Control Number: 35077

Filing Clerk
Public Utility Commission of Texas
1701 N. Congress Avenue
P.O. Box 13326
Austin, TX 78711-3328
Re: Project No. 35077

**AMENDMENT NO. 1 TO THE
ERCOT STANDARD GENERATION INTERCONNECTION AGREEMENT**
Between Palmas Wind, LLC and South Texas Electric Cooperative (STEC)
For GINR 17INR0037---Palmas Wind Energy Project

ONE-LINE
PALMAS ALTAS
WIND 1A

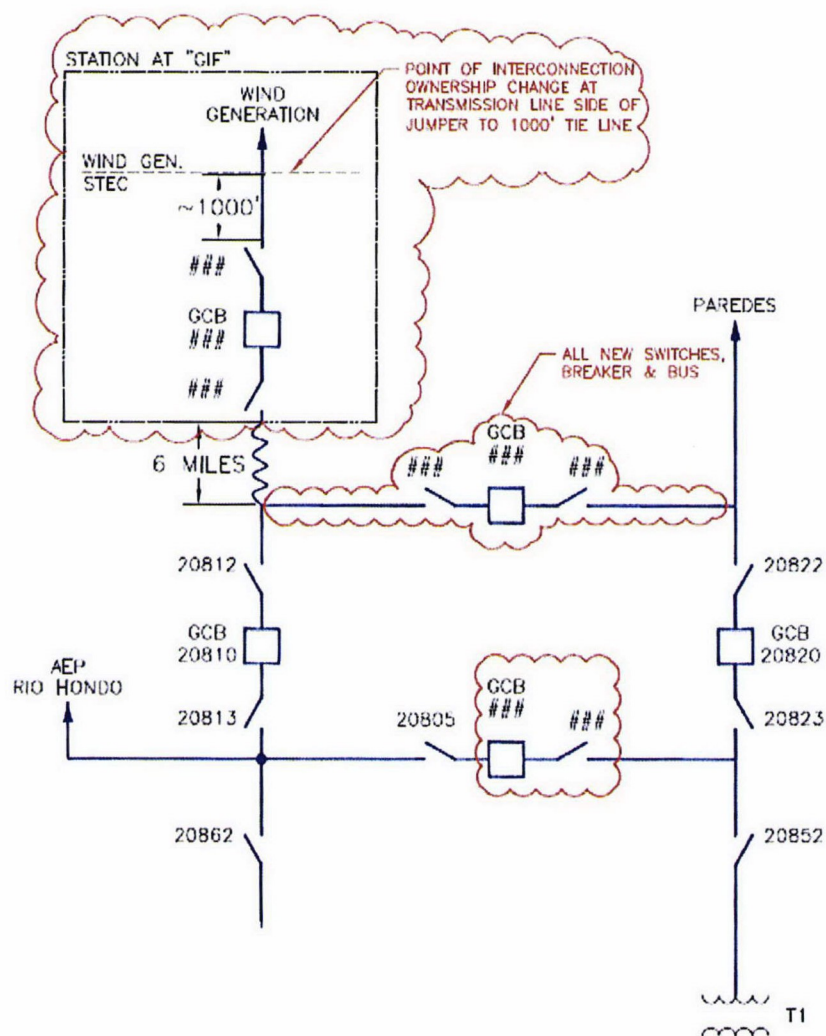
WHEREAS, the Parties agree that the Transmission Service Provider Interconnection Facilities as described in the Generation Interconnection Agreement did not include approximately 1000 feet of 138kV line from the STEC dead-end to the GIF;

WHEREAS, the Parties have agreed to amend the One-line Drawing set forth in Exhibit “C” (Interconnection Details) to the Generation Interconnection Agreement to include approximately 1000 feet of conductor.

- 8) **Transmission Service Provider Interconnection Facilities:** The TSP interconnection facilities will generally consist of 1) a 138 kV line terminal at the East Rio Hondo substation or other effective location 2) approximately 6 miles of 138 kV transmission line 3) a 138 kV line terminal at the station containing the GIF, including but not limited to a dead-end structure, a 138 kV line breaker with associated protective relaying, air disconnect switches and bus work, and EPS metering instrument transformers and devices and (4) approximately 1000 feet of 138kV line from the STEC dead-end to the dead-end structure owned by the Generator at the GIF including the associated insulators.
